Transport Review

Warrawong Plaza State Assessment Planning Proposal

NSW Department of Planning & Environment

**File Reference:** P0432r1v5 Warrawong Plaza SAPP Transport Review

Figure 2: Urban Design Report Vehicle Access Plan

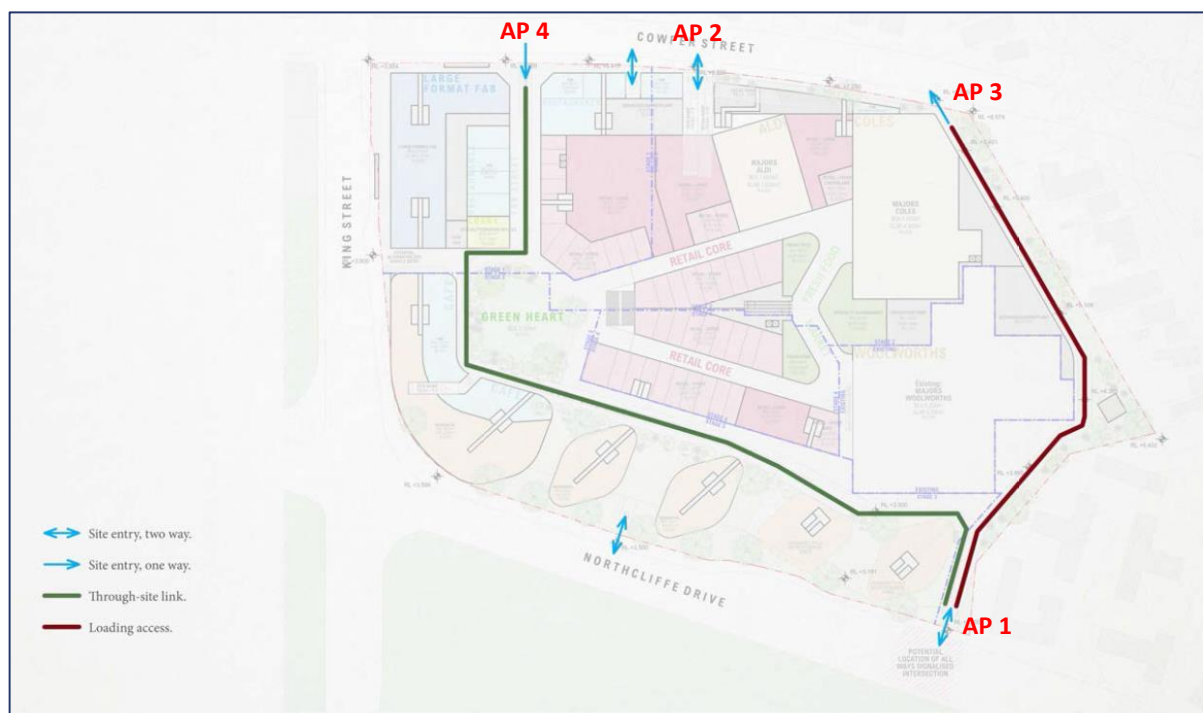
While the **Northcliffe Drive & AP 1** intersection will be upgraded to a signalised intersection, the Cowper Street access points and additional Northcliffe Drive access point would all provide for left in/left out movements only given the location of central medians in both roads.

With regard to the access point in Cowper Street between AP 2 and AP 4, it is noted that this access point is not shown in the more detailed plans provided in the UD Report.

Based on the available SAPP documents, it is difficult to determine how appropriate service vehicle access would be provided across the Site. The only service route identified in the Vehicle Access plan ([Figure 2](#)) is a one-way route between AP 1 and AP 3, and there is no information as to how deliveries to individual sites would occur.

Figure 3: Internal Road Connection to Northcliffe Drive

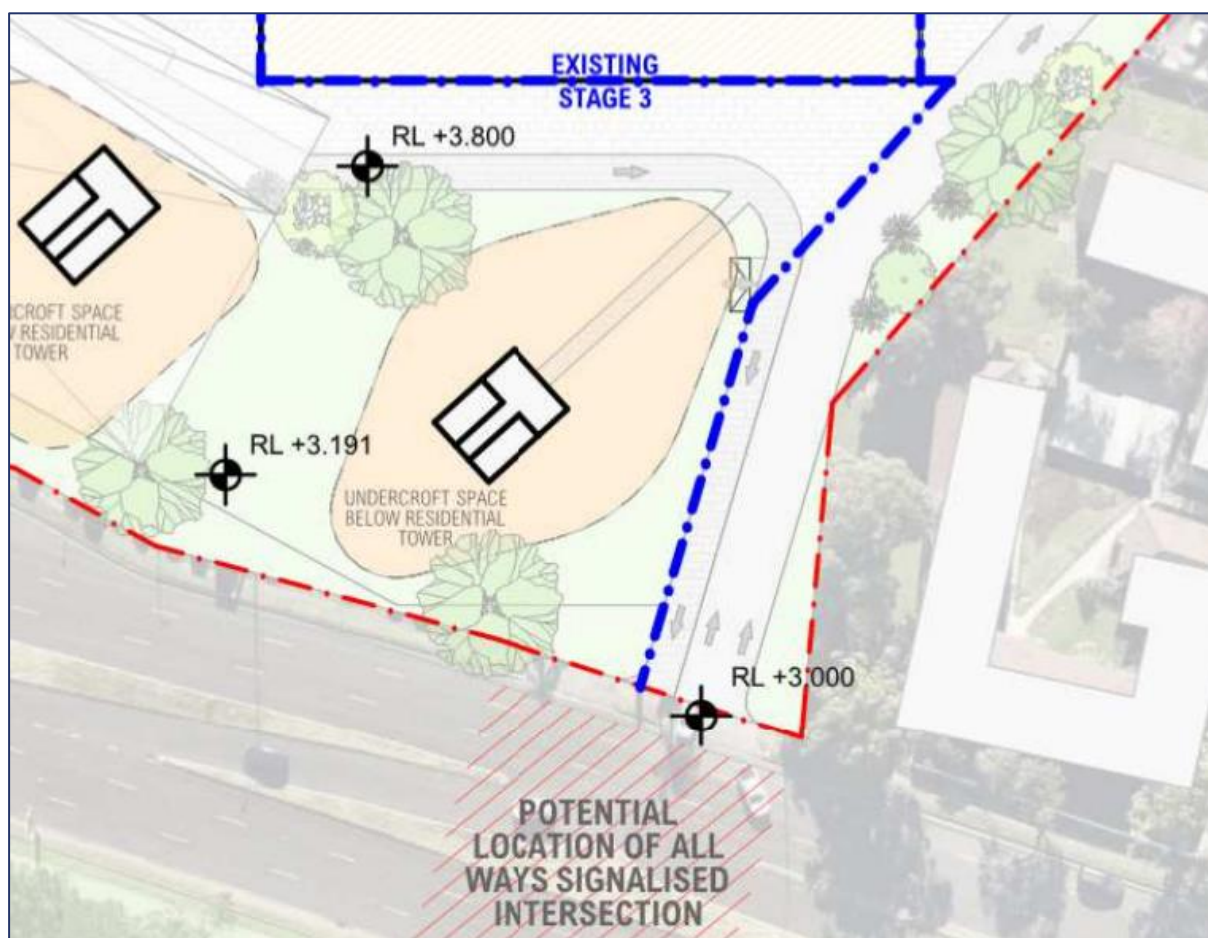
The purpose and operation of the internal road is unclear. In this regard, the Vehicle Access plan indicates that this will be a one-way link between AP 4 and AP 1, but the UD Report plans show two way access in the section of the internal road immediately south of Cowper Street.

The UD Report plans also indicate that the internal road would link to Northcliffe Drive immediate west of AP 1 which would not be permitted; this connection is shown in Figure 3 below.

Figure 4: Northcliffe Drive & AP 1 Intersection Upgrade

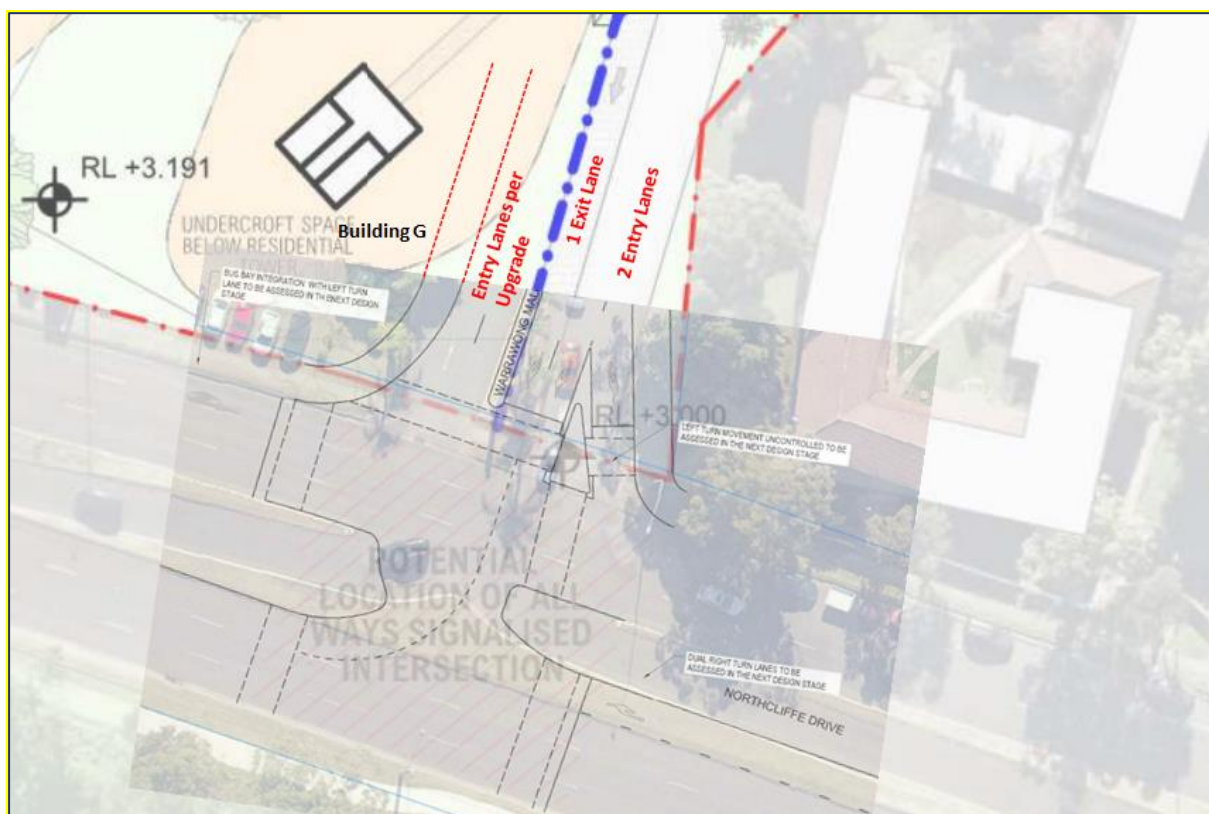
Further to the above, the broader design of AP 1 shown in the UD Report plans is very different to the intersection upgrade plan in Appendix C of TIA V2. Per Figure 3 above, the UD Report ground floor plan shows 2 entry lanes and - as discussed - 1 exit lane from Internal Road (west of the entry lanes). As such, the design shown in the UD Report plans provides no exit lanes from the Site to Northcliff Drive other than from Internal Road.

While acknowledging that the plans will evolve, the UD Report plans should be updated to show the proposed upgrade of Northcliffe Drive & AP 1 as the area required for the upgrade is significantly larger than shown as being available in the UD Report plans. Indeed, this would appear to require the redesign of Building G as the entry lanes for the upgraded intersection would otherwise run through Building G, as shown in Figure 4 below.

Finally, the UD Report plans then show the entry lanes merging to a single lane providing access to the service vehicle road (through to AP 3), i.e. no access to internal parking. This again points to the need for more information in regard to internal circulation and what parking is accessed via each proposed access point as discussed in Section 3.3.2.
